United States Patent and Trademark Office

APPLICATION NO.	1	FILING DATE	FIRST NAMED INVENTOR	ATTORNEY DOCKET NO.	CONFIRMATION NO.
10/616,830	330 07/10/2003		Maurizio Valle	CAM3-PT045	2681
3624	7590	05/01/2006		EXAMINER	
VOLPE A			SCHARICH, MARC A		
UNITED PLAZA, SUITE 1600 30 SOUTH 17TH STREET				ART UNIT	PAPER NUMBER
PHILADEL	PHILADELPHIA, PA 19103			3611	
				DATE MAILED: 05/01/2006

Application No.	Applicant(s)					
	10/616,830	VALLE, MAURIZIO					
Office Action Summary	Examiner	Art Unit					
	Marc A. Scharich	3611					
The MAILING DATE of this communication appears on the cover sheet with the correspondence address Period for Reply							
A SHORTENED STATUTORY PERIOD FOR REPLY IS SET TO EXPIRE 3 MONTH(S) OR THIRTY (30) DAYS, WHICHEVER IS LONGER, FROM THE MAILING DATE OF THIS COMMUNICATION. - Extensions of time may be available under the provisions of 37 CFR 1.136(a). In no event, however, may a reply be timely filed after SIX (6) MONTHS from the mailing date of this communication. - If NO period for reply is specified above, the maximum statutory period will apply and will expire SIX (6) MONTHS from the mailing date of this communication. - Failure to reply within the set or e

Fig. 3 (From Campagnolo U.S. Patent No. 5,935,034)

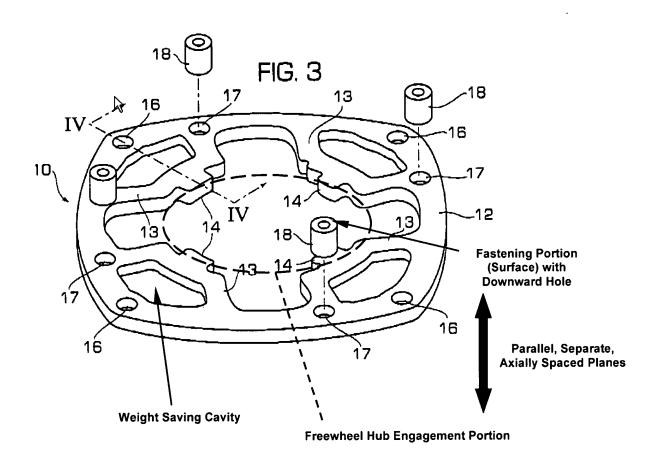
Claims 1, 3-9, and 33-35 are rejected under 35 U.S.C. 102(b) as being anticipated by Campagnolo, U.S. Patent No. 5,935,034.

Campagnolo discloses a sprocket support member (10) [see included Fig. 3 from Campagnolo], comprising: a fastening portion that appears to have an axial thickness substantially equal to a desired axial distance between multiple sprockets of the sprocket assembly [thickness of spacers 18] (Fig.1); at least one freewheel hub engagement portion having at least one tooth (14); and at least one fastening portion [see included Fig. 3] presenting at least one hole (17 projected axially through 18); wherein the fastening portion is defined within a first plane and the engagement portion is defined in a second plane and the planes are parallel to each other in separate, projected axially spaced planes, although the engagement portion and fastening portion are considered to be a single structural unit [via being connected through spacers 18]; the spacers (18), that provide an axial projection of the fastening portion from the engagement portion, form a support for a radially projecting element (such as a sprocket surface radially projecting outwardly and forming multiple teeth]. Additionally, Campagnolo discloses the sprocket support member (10) having weight saving cavities (as shown in Figs 3 and 4).
